FORM APPROVED
OMB NO. 1004-0135
Expires: July 31, 2010**SUNDRY NOTICES AND REPORTS ON WELLS**
*Do not use this form for proposals to drill or to re-enter an abandoned well. Use form 3160-3 (APD) for such proposals.*5. Lease Serial No.
NMLC029395B

SUBMIT IN TRIPLICATE - Other instructions on reverse side.8. Well Name and No.
LEE FEDERAL 51

Apache Corporation proposes to use a 13-5/8" 3M psi WP BOP (EXHIBIT 3) consisting of an annular bag type preventer. The BOP will be nipped up on the 13-3/8" surface csg head & tested to 2000psi using a test plug. After intermediate csg is set & cemented a 13-5/8" or a 11" 3M BOP consisting of an annular bag type preventer, middle blind rams, and bottom pipe rams (see EXHIBIT 3A) will be installed & utilized continuously until TD is reached. The BOP will be tested at 2000 psi (maximum surface pressure is not expected to exceed 2M psi). BHP is calculated to be approximately 2819 psi. All BOPs & associated equipment will be tested as per BLM Drilling Operations Order #2. The BOPs will be operated and checked each 24 hr period & the blind rams will be operated & checked when the drill pipe is out of the hole. Functional tests will be documented on t

Drilling Location
H2S Safety Equipment Diagram
Exhibit 3A

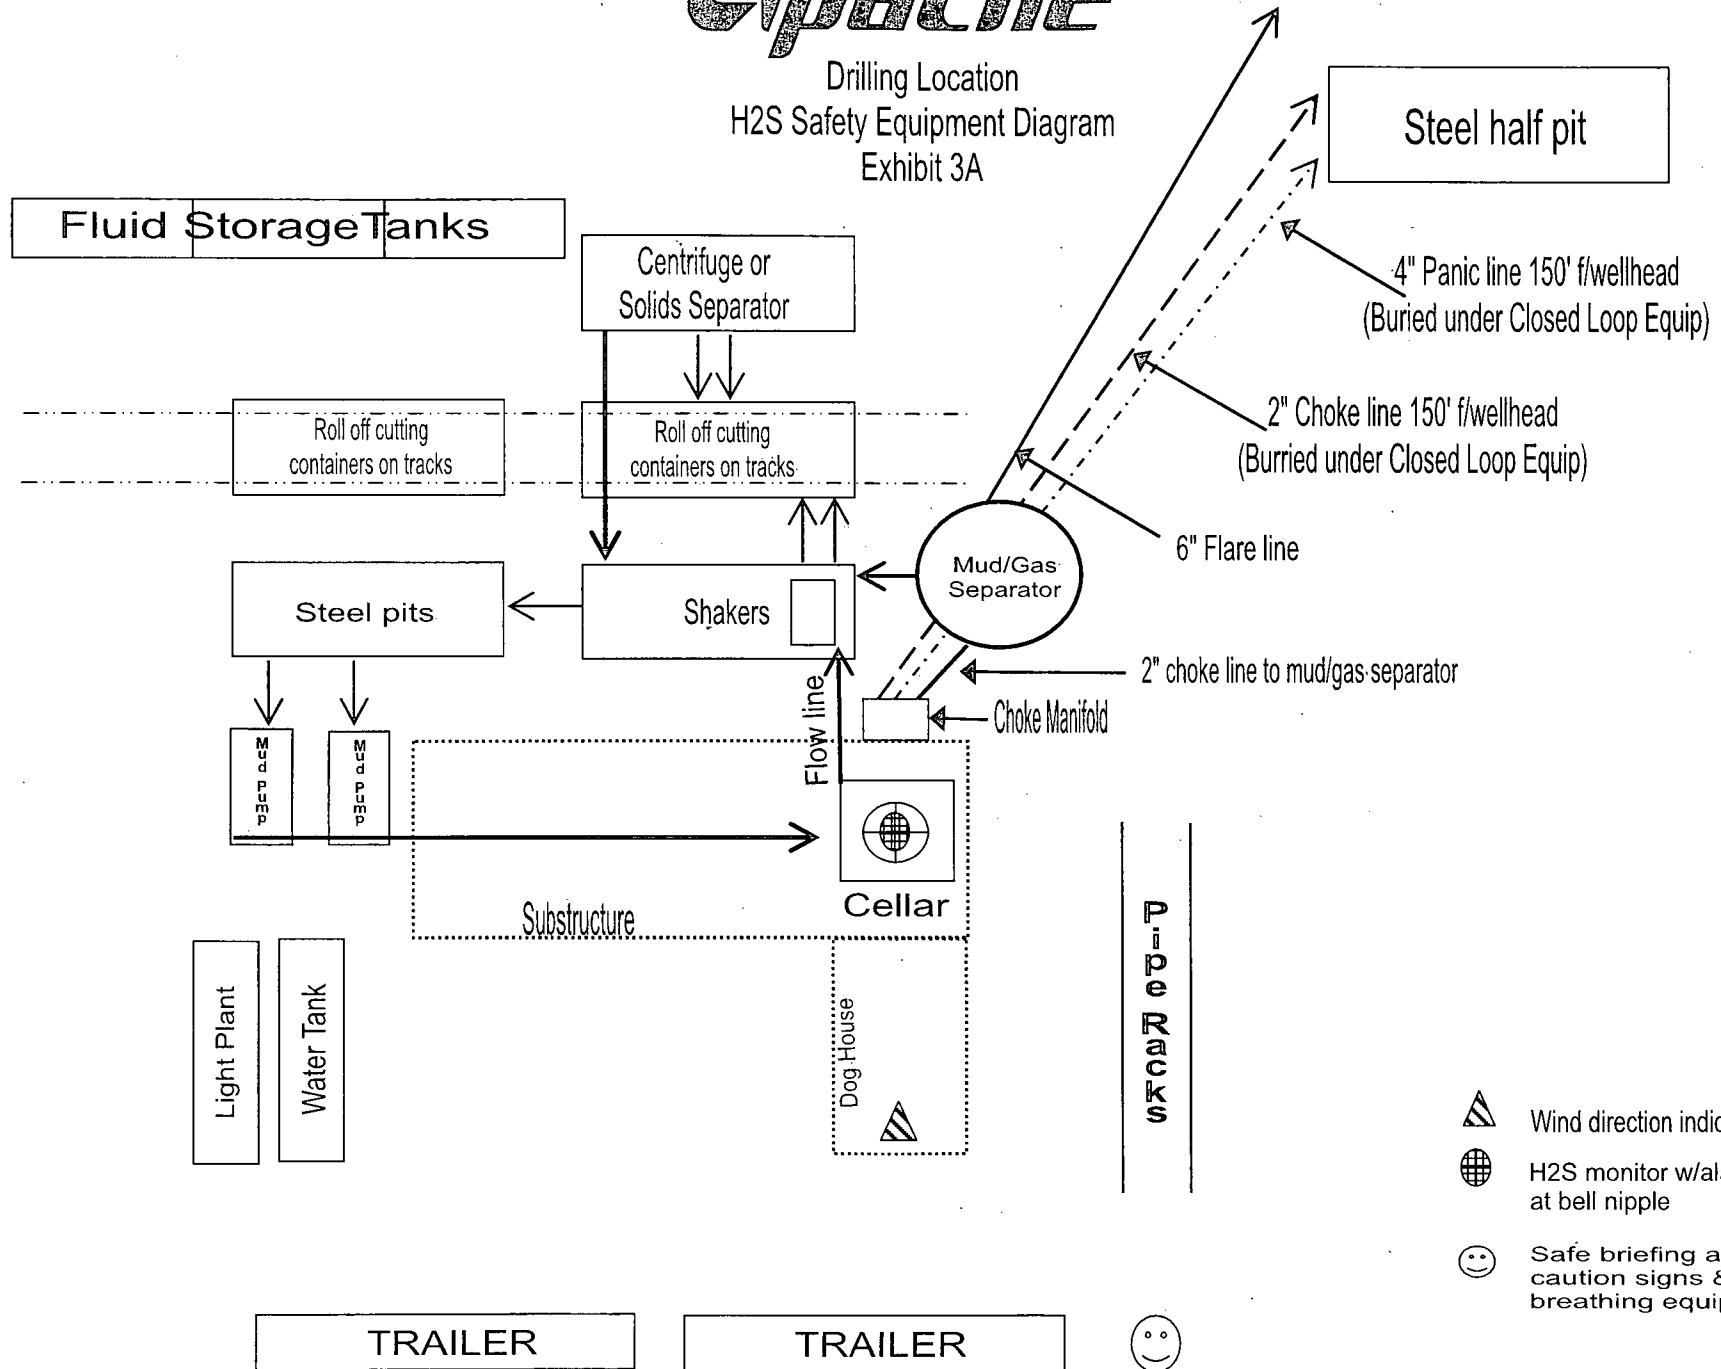
A Hydrogen Sulfide (H₂S) Drilling Plan should be activated **500 feet** prior to drilling into the **Grayburg** formation. **As a result, the Hydrogen Sulfide area must meet Onshore Order 6 requirements, which includes equipment and personnel/public protection items. If Hydrogen Sulfide is encountered, please provide measured values and formations to the BLM.**
